**MONTGOMERY COLLEGE - OFFICE OF PROCUREMENT
UNDERGROUND CHILLED AND HEATING WATER PIPING REPLACEMENT – PHASE 1
ROCKVILLE CAMPUS
RFP NO.: E621-006
RFP CLOSING DATE AND TIME: APRIL 9, 2021 @ 2:00 PM**

**ADDENDUM #1
Issued: March 31, 2021**

**BKM PROJECT NO. 19104.01
 ADDENDUM 1
 APRIL 1, 2021**

M1.04

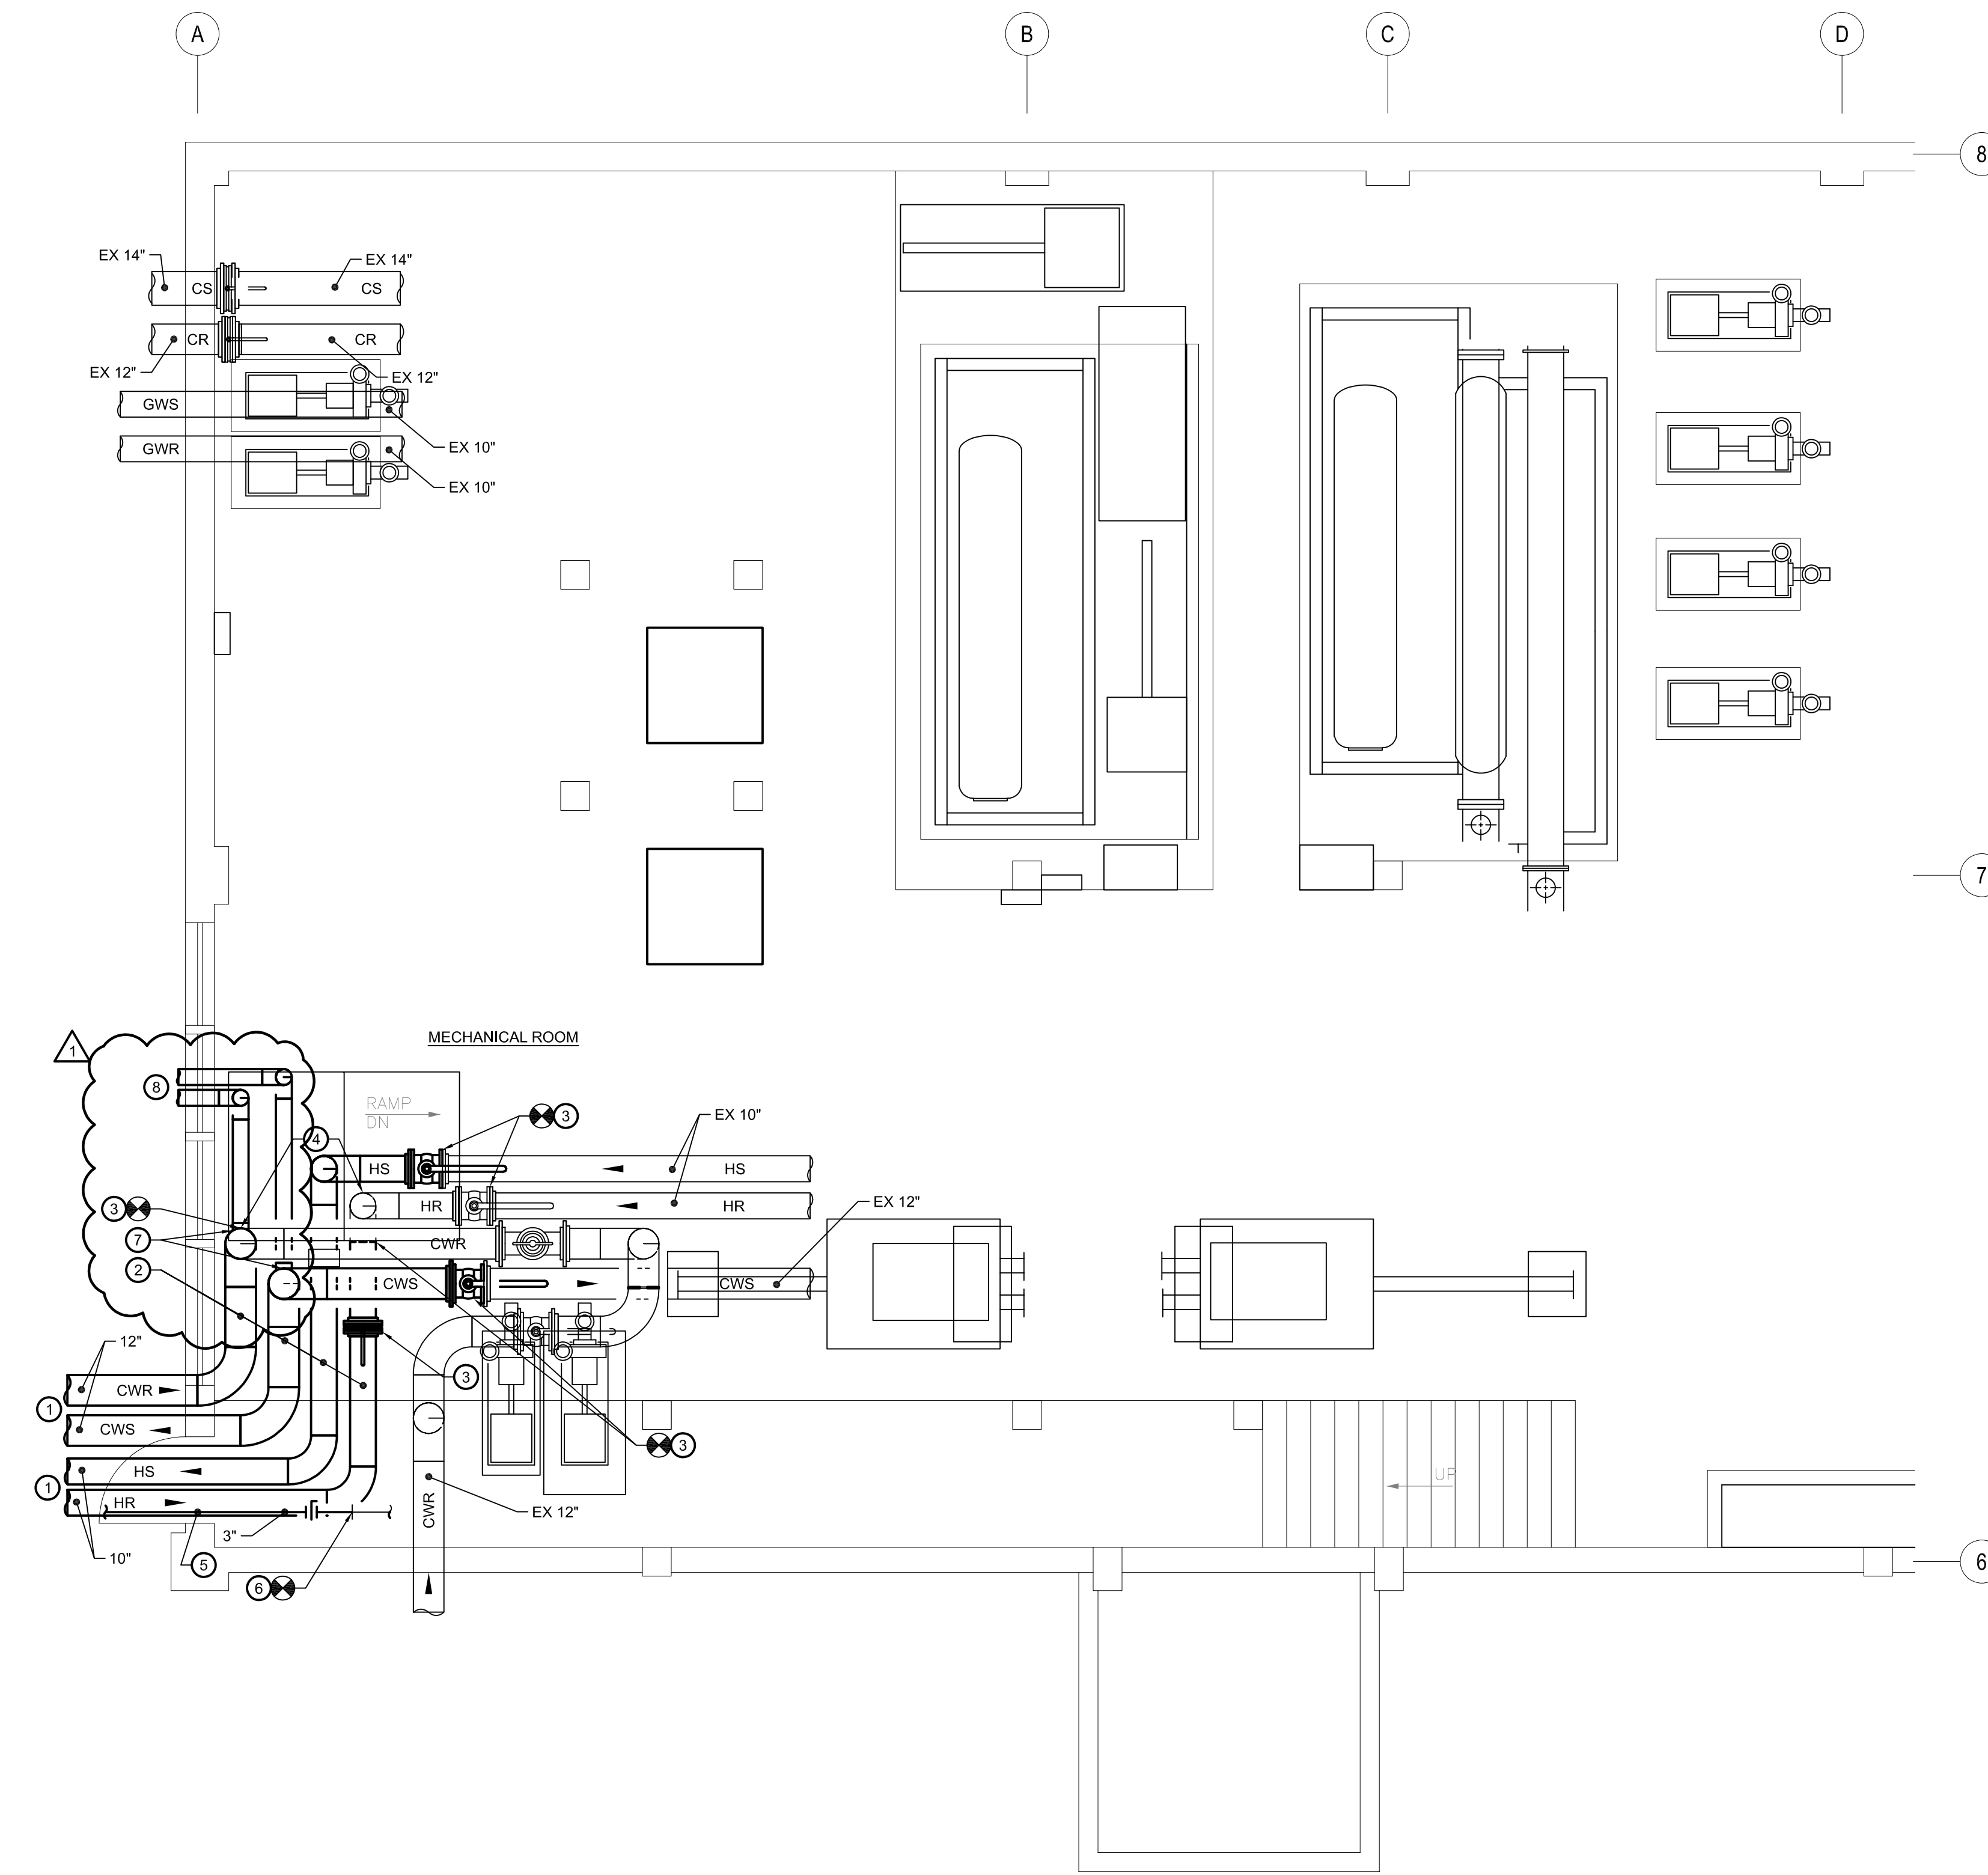
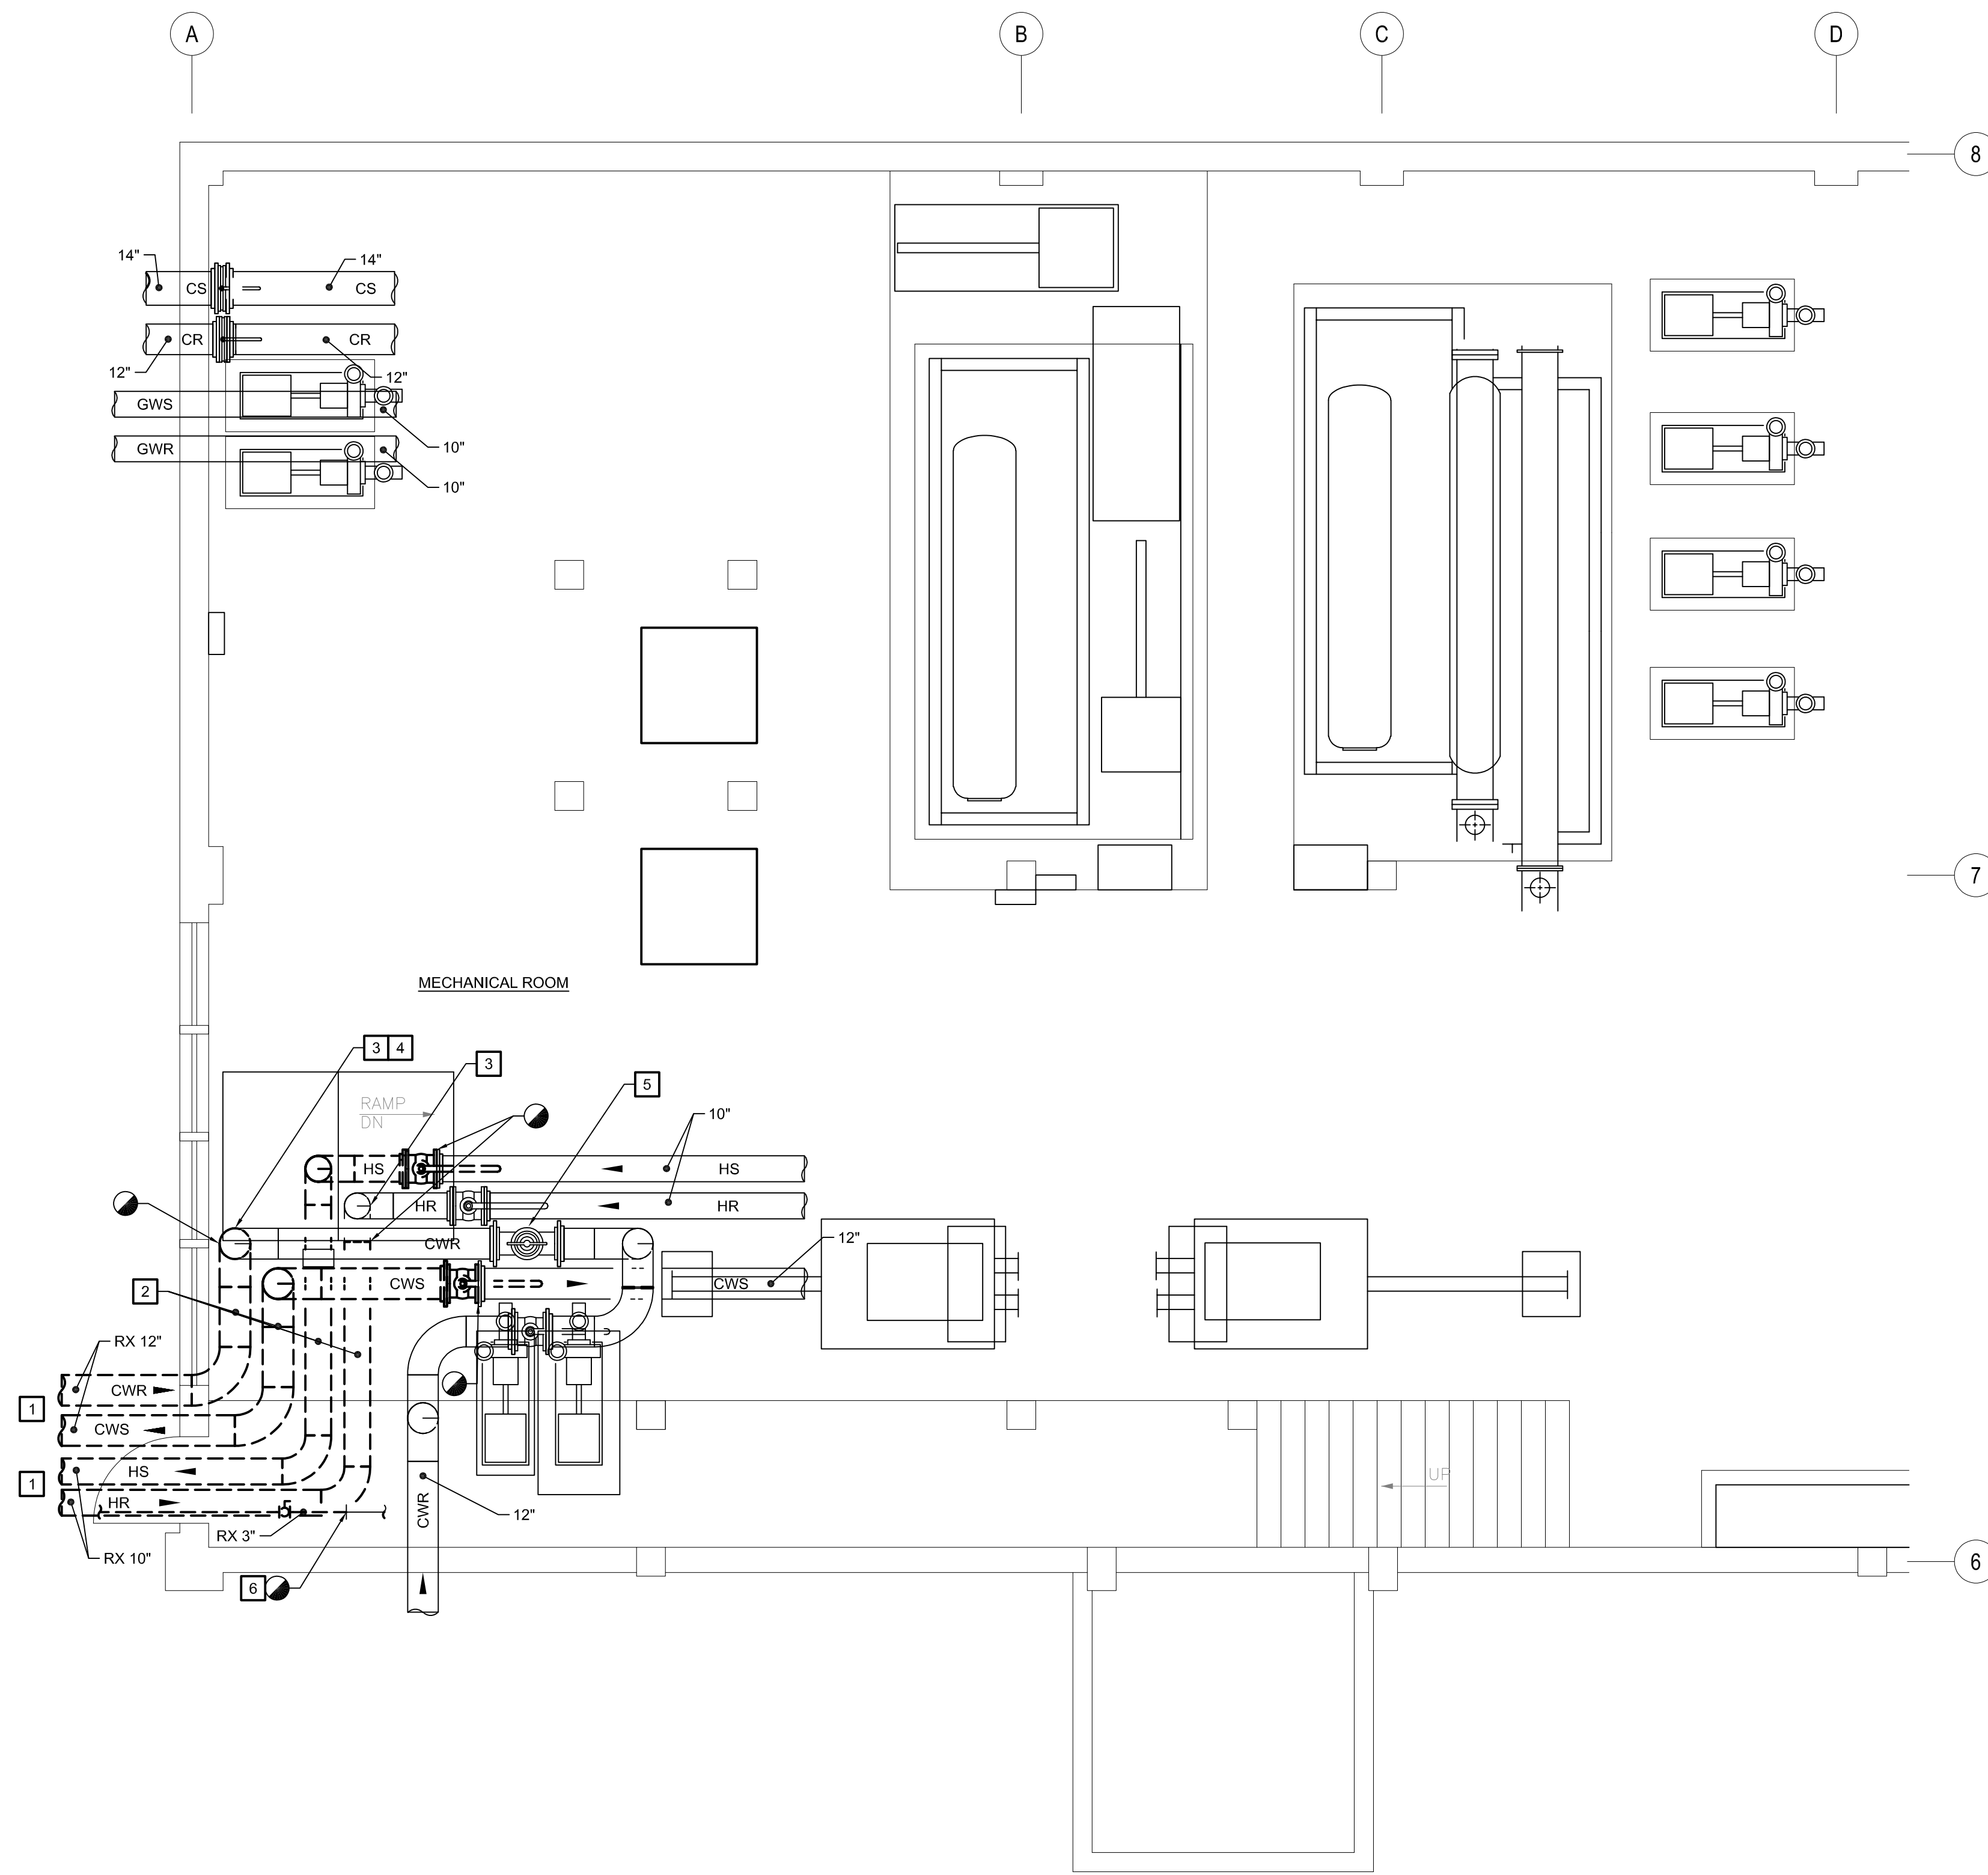
M1.04: Addition of general notes for temporary chilled water piping.

M2.01

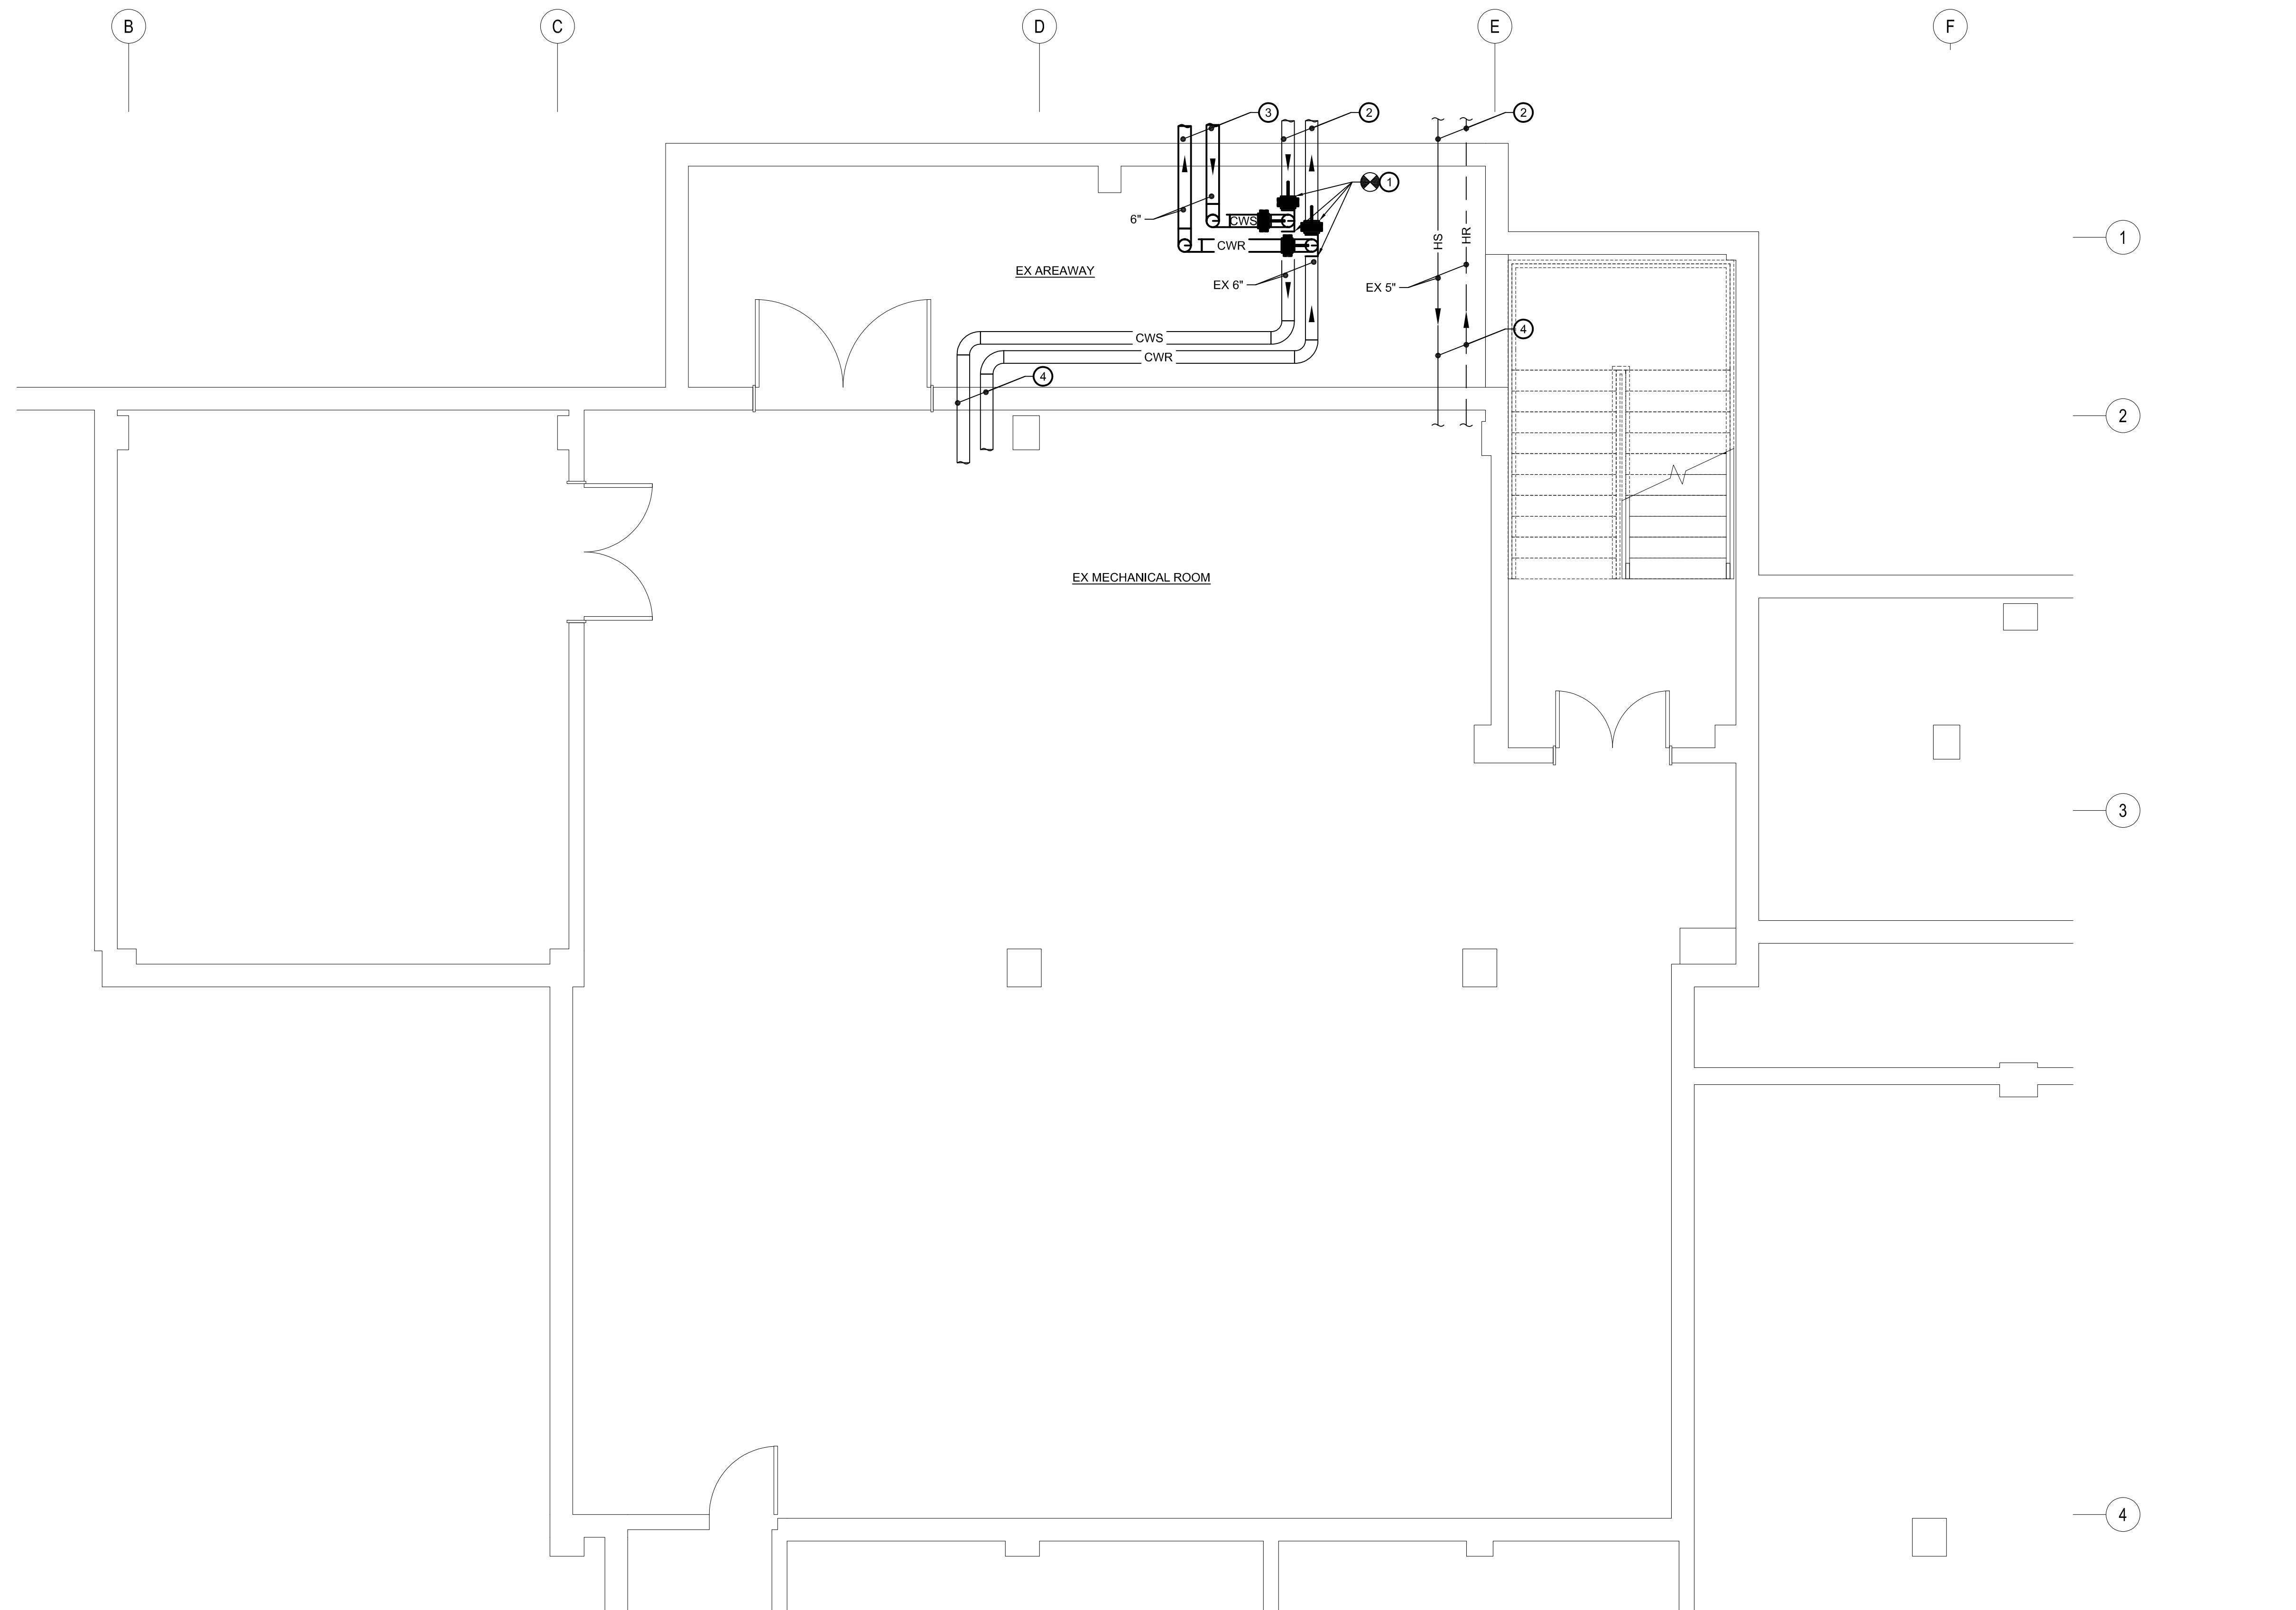
M2.01: Addition of 6” flanged connections for temporary piping connections.

- PROVIDE NEW 6" FLANGED CONNECTION WITH NEW SHUTOFF VALVES ON CHILLED WATER SUPPLY & RETURN PIPING FOR TEMPORARY CHILLED WATER PIPING CONNECTION. EXTEND TEMPORARY PIPING FROM FLANGED CONNECTION TO MACKLIN TOWER FOR EXTENT OF CHILLED WATER OUTAGE TO MACKLIN TOWER. REMOVE AND CAP FLANGE AT COMPLETION OF CHILLED WATER OUTAGE.

- TEMPORARILY ROUTE 6" 150 PSIG CHILLED WATER FLEXIBLE PIPING THROUGH ROLL-UP DOOR TO MACKLIN TOWER. COORDINATE ROUTING WITH ALL CONSTRUCTION ACTIVITIES AND PROVIDE PROTECTIVE MEASURES TO PREVENT DAMAGE TO PIPING FOR EXTENT OF USAGE.
